REQUEST

Current Zoning: R-5 (single family residential)
Proposed Zoning: MUDD(CD) (mixed use development, conditional)
with 5-year vested rights

Approximately 0.517 acres located on the west side of the intersection of Seigle Avenue and E. 15th Street.
(Council District 1 - Egleston)

SUMMARY OF PETITION

- **Proposed Request Details**

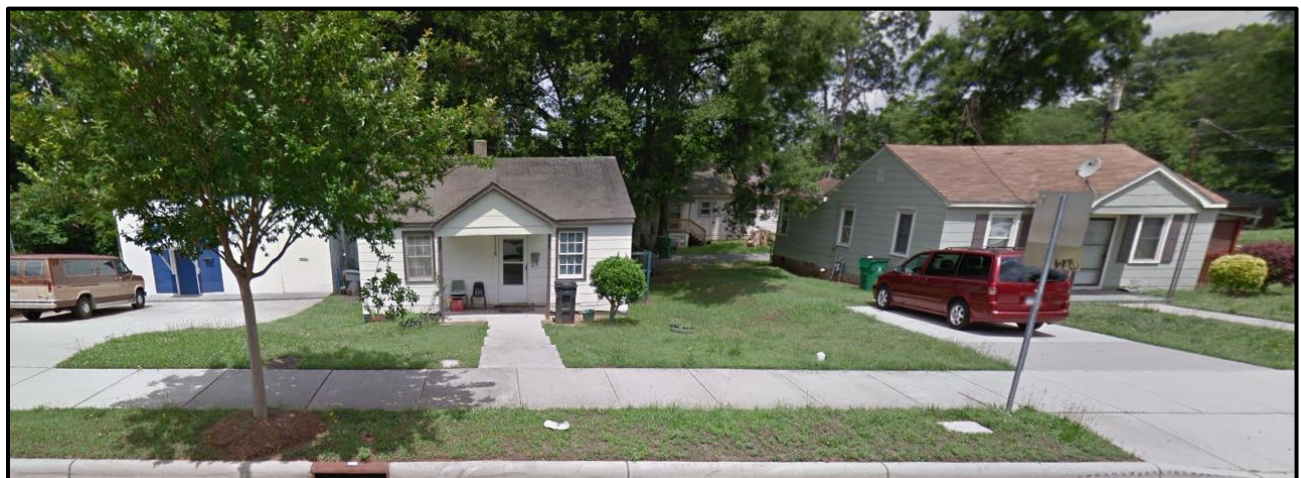
1. Reduce the density to not exceed five dwelling units per acre.
2. Remove the request for 5-year vested rights.
3. Amend Note 2A to delete commercial uses. If commercial space will be included specify the maximum square footage allowed.

4. Rebuild the receiving ramps at the corner of Seigle Avenue and East 15th Street to meet City of Charlotte and PROWAG standards.

5. Amend Note 5 to remove "in the sole discretion of petitioner."
6. Show and label required space for dumpster(s)/compactor and recycling, which is required to be set aside even if property owner and/or developer elects to use a private hauler for individual rollout cart service.

7. Amend Note 4D to delete all verbiage after "By Section 6.207 of the ordinance."
8. Specify Tree Save information under heading of Development Data.
9. Correct the discrepancy between the number of parking spaces provided and the parking ratio specified in the site development data table.

10. Add the following notes under heading of Architectural and Site Design:
 - a. All principal and accessory buildings abutting a network required public or private street shall comprise a minimum of 30% that building's entire façade facing such network street using brick, natural stone (or its synthetic equivalent) stucco or other material approved by the planning director.

- b. List the following as prohibited building materials: vinyl siding as a prohibited exterior building material except on hand rails, windows or door trim; concrete masonry units not architecturally finished.

- c. Buildings shall be placed so as to present a front or side façade to all network required streets (public or private); buildings shall front a minimum of 60% of the total network required street frontage on the site (exclusive of driveways, pedestrian access, points, accessible open space, tree save or natural areas, tree replanting areas and storm water facilities); parking lots shall not be located between any building and any network required public or private street; driveways intended to serve single units shall be prohibited on all network required streets.

- d. Buildings exceeding 120 feet in length shall include modulations of the building massing/façade plane (such as recesses, projections, and architectural details). Modulations shall be a minimum of 10 feet wide and shall project or recess a minimum of six feet extending through the building.

- e. Building elevations shall be designed with vertical bays or articulated architectural façade features which may include but not be limited to a combination of exterior wall offsets, projections, recesses, pilasters, banding and change in materials or colors; buildings shall be designed with a recognizable architectural base on all facades facing network required public or private streets. Such base may be executed through use of preferred exterior building materials or articulated architectural facades features and color changes; building elevations facing network required public or private streets shall not have expanses of blank walls greater than 20 feet in all directions and architectural features such as but limited to banding,

- medallions or design features or materials will be provided to avoid a sterile, unarticulated blank treatment of such walls.
- f. Roof form and lines shall be designed to avoid the appearance of a large monolithic roof structure as follows: long pitched or flat roof lines shall avoid continuous expanses without variation by including changes in height and/or roof form to include but not be limited to gables, hips, dormers or parapets; for pitched roofs the minimum allowed is 4:12 excluding buildings with a flat roof and parapet walls; roof top HVAC and related mechanical equipment will be screened from public view at grade from the nearest street.

- g. Service areas such as dumpsters, refuse areas, recycling and storage shall be screened from view with materials and design to be compatible with principal structures. Such design shall include a minimum 20% preferred exterior building materials or a Class B buffer not less than 10 feet in depth at all above grade perimeter not paved for access.

- h. Sidewalk extensions should be provided between all street trees on all public and private network required streets when parking is adjacent.

11. Amend Note 5(A) to add the following notes:

For defined watersheds greater than 24% built-upon area (BUA), construct water quality stormwater control measures (SCMs) designed for the runoff generated from the first 1-inch of rainfall for all new and redeveloped BUA associated with the project. SCMs must be designed and constructed in accordance with the Charlotte-Mecklenburg BMP Design Manual.

For defined watersheds greater than 24% built-upon area, control the entire volume for the 1-year, 24-hour storm for all new and redeveloped BUA associated with the project. Runoff volume drawdown time shall be in accordance with the Charlotte-Mecklenburg BMP Design Manual.

For commercial projects with greater than 24% BUA, control the peak to not exceed the predevelopment runoff rates for the 10-yr, 6-hr storm and perform a downstream flood analysis to determine whether additional peak control is needed and if so, for what level of storm frequency, or if a downstream analysis is not performed, control the peak for the 10-yr and 25-year, 6-hour storms.

For residential projects with greater than 24% BUA, control the peak to not exceed the predevelopment runoff rates for the 10-year and 25-year, 6-hour storms or perform a downstream analysis to determine whether peak control is needed, and if so, for what level of storm frequency.
